State-of-the-Art Reactor Consequence Analyses (SOARCA) Project

Appendix A Peach Bottom Integrated Analysis

Revision 1 ~~Draft~~ - 12/17/2009 1:11:00 PM

Figure 4 Reactor Vessel Cross-Section Detail and MELCOR Hydrodynamic Nodalization

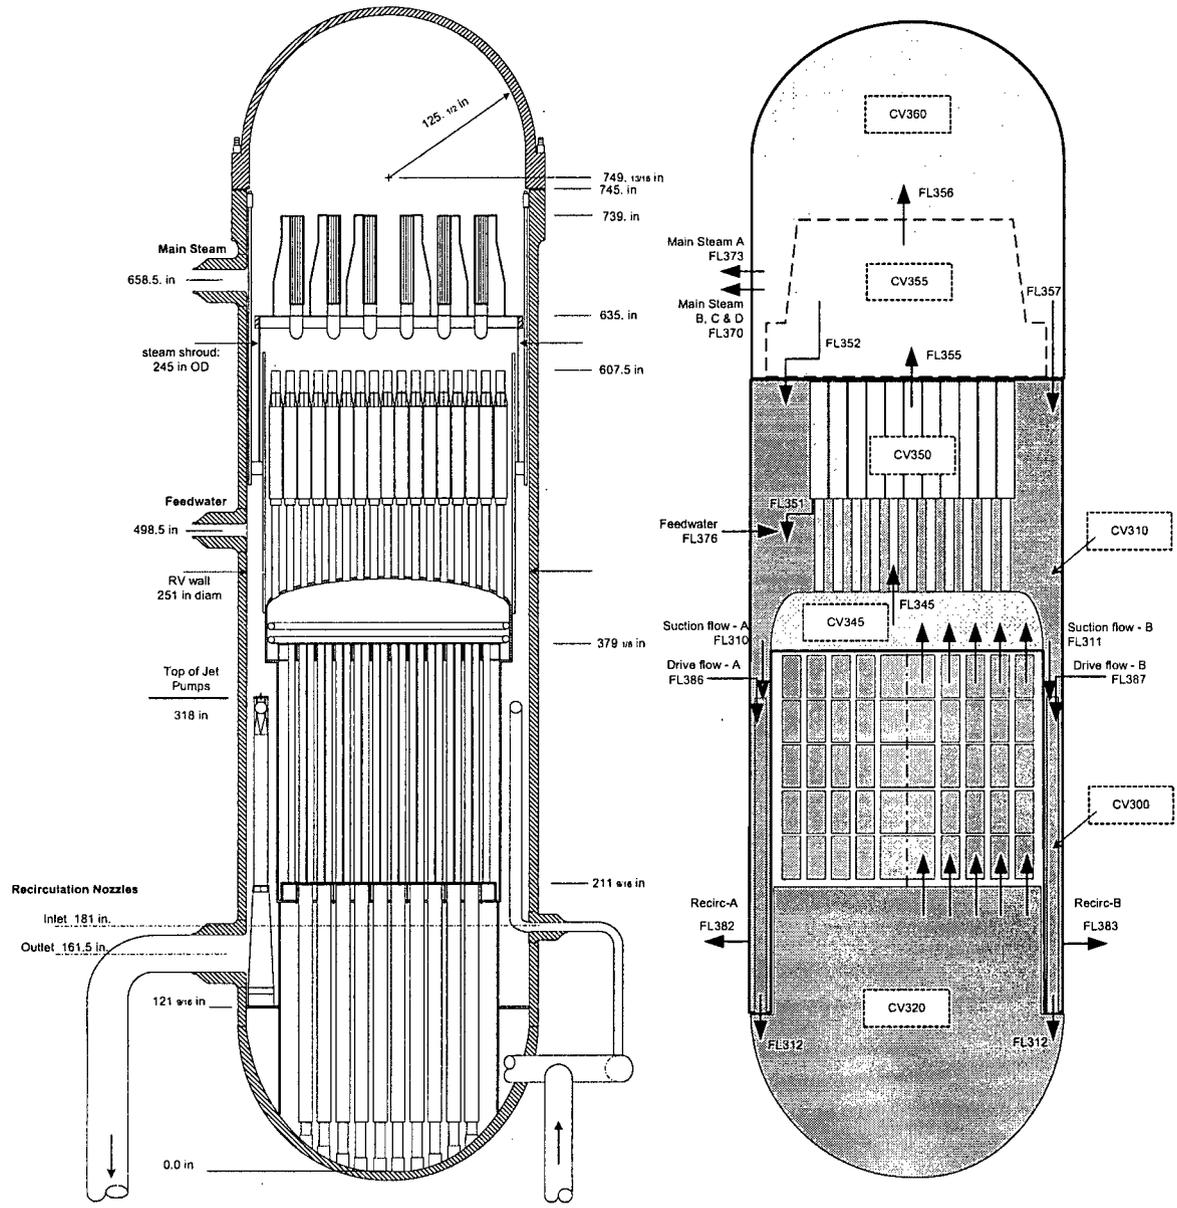
And there are discussed in section

Figure 13 Drywell Flange Leakage Model versus Containment Pressure

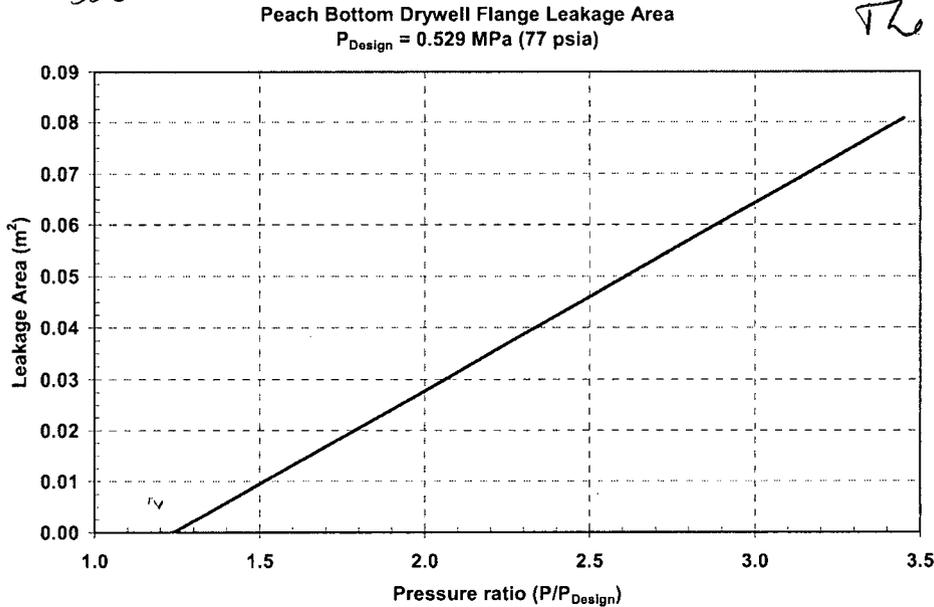
Section 4.4 only discusses transport of debris

The word "failure" is never used.

Figure 21 LTSBO Environmental Source Term: Long term

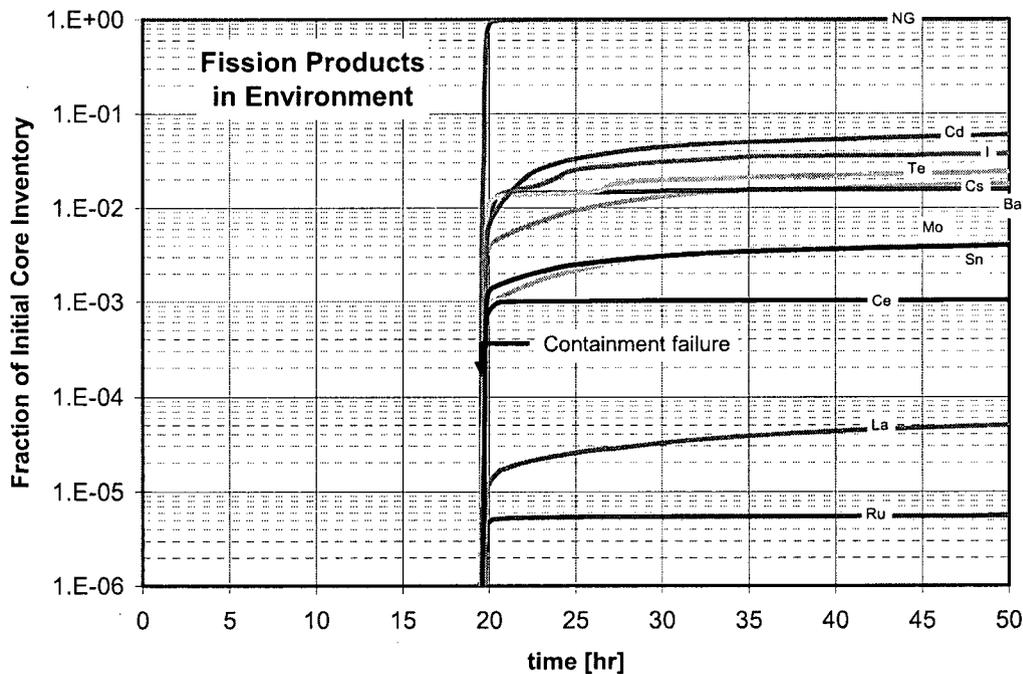
If you carried out the calc to 96 hours (Table 3) plot it all
